**Monitoring Report
Year 4
FINAL**

Little Buffalo Creek Stream Mitigation Project

*NCDEQ-DMS Project Number: 94147
Contract Number: 2029
USACE Permit Action ID: 2014-00386
DWR Permit: 14-0129
Cabarrus County*

Subject: DRAFT Monitoring Year 4 report for the
Little Buffalo Creek Stream Mitigation Project
Yadkin River Basin – CU# 03040105– Cabarrus County
DMS Project ID No. 94147
Contract # 002029

LEGEND:

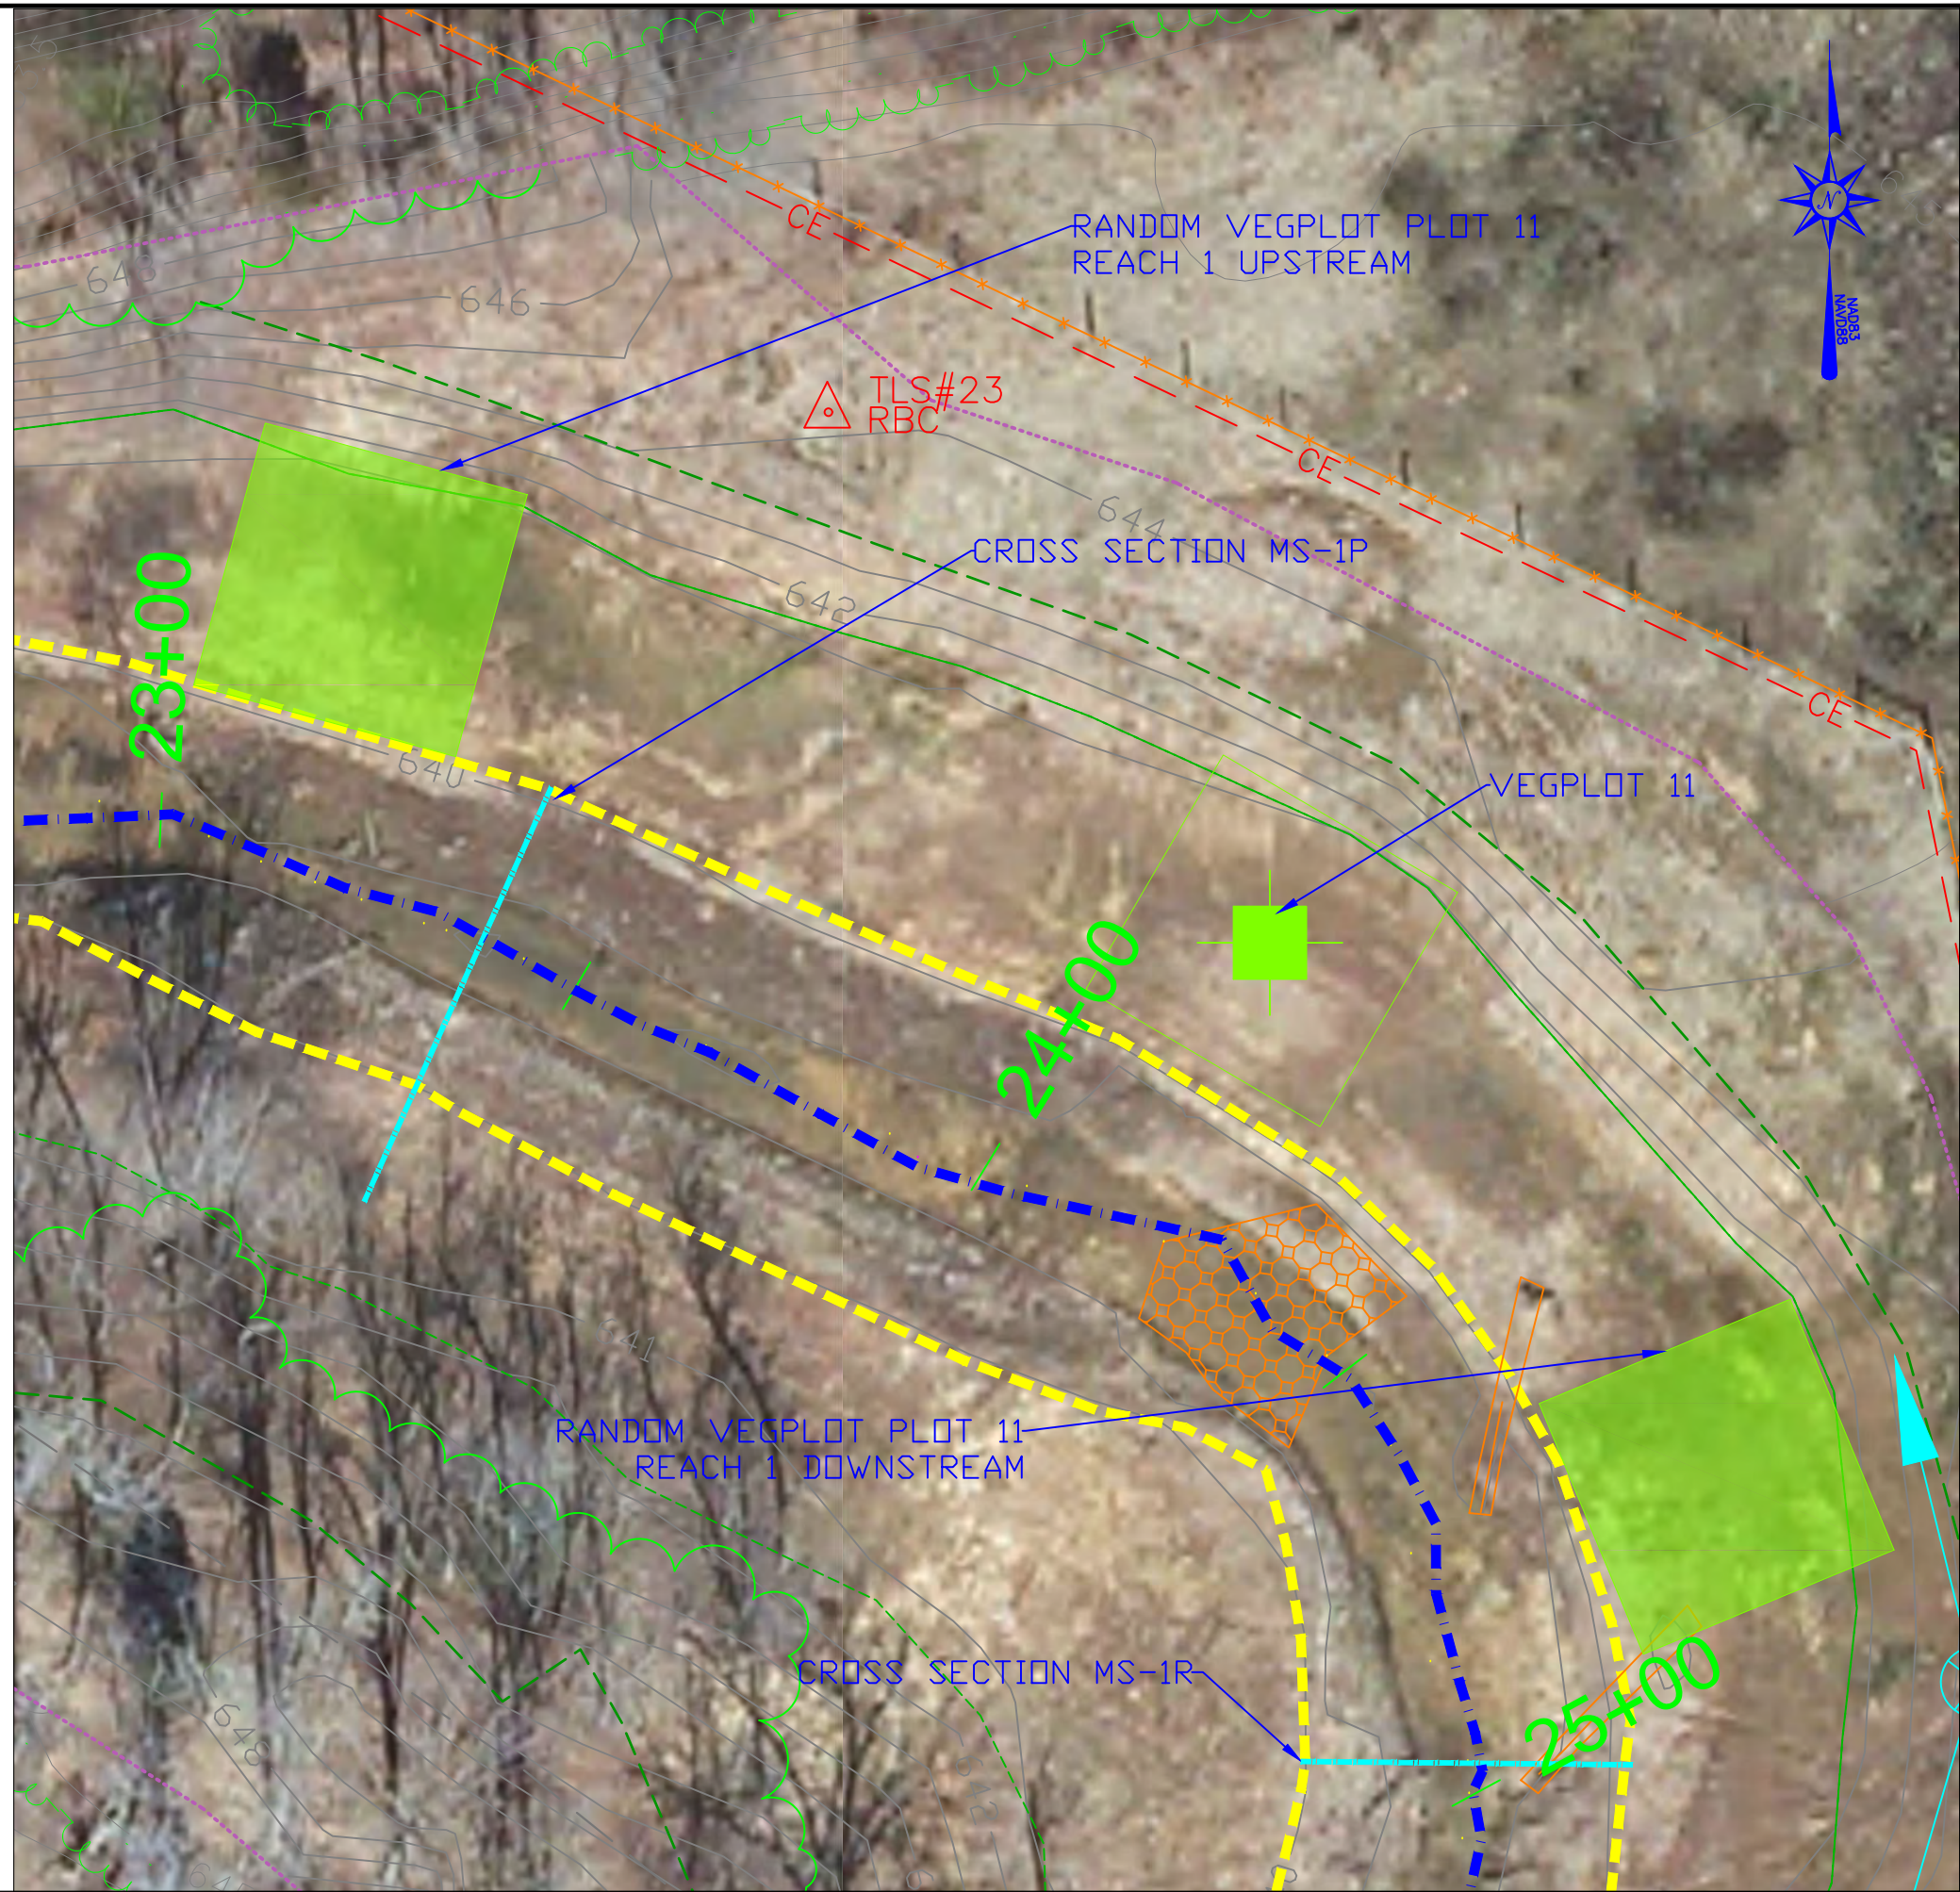
Section 1.5.1.3 – Random Vegetation Plots: The report text indicates that the random vegetation plots are shown in Figure 2. The plots are shown in the CCPV sheets but they do not appear to be in a standalone figure 2. Please update the report text accordingly. DMS recommends including a simple map or set of simple maps showing the random plots to go along with Table 14 in the report appendices.

- **Section 1.5.1.3 – Random Vegetation Plots:** The report text indicates that the random vegetation plots are shown in Figure 2. The plots are shown in the CCPV sheets but they do not appear to be in a standalone figure 2. Please update the report text accordingly. DMS recommends including a simple map or set of simple maps showing the random plots to go along with Table 14 in the report appendices.
 - *Figure 2 is referring to Figure 2a- 2j for the MY4 CCPV. The report text has been updated accordingly to refer to the CCPV. Figure 7a-d has been created and placed with Table 14 to show closer views of each random transect in relation to the vegetation plot.*
